Ball Check Valve in Rocker Box Covers

Fig. 16

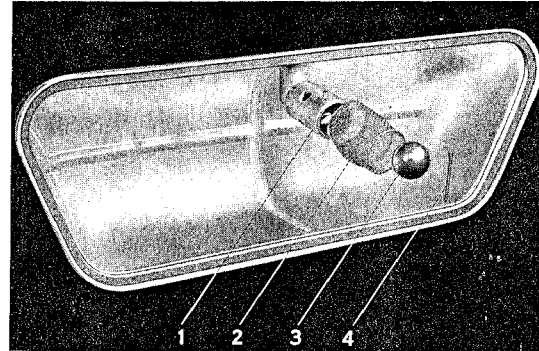
A ball check valve has been installed in the rocker box covers to prevent oil loss through the breather hole while traveling in fast curves. The check valve should be cleaned with solvent and inspected for proper operation when the valve clearance is adjusted. Disassemble and clean the valve if necessary.
